PJM Global CETL Study Areas

PJM Zonal CETL Study Areas

Figure E-3 (Cleveland LDA)

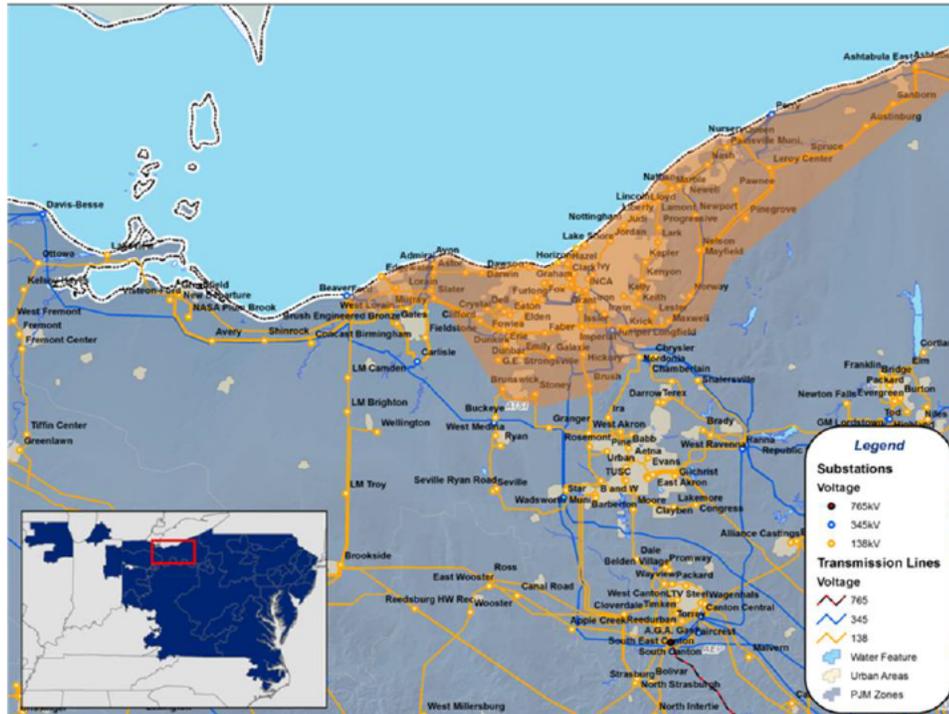
[Cleveland – All load and generation connected at 345kV and below as defined in Figure E-3.](#)
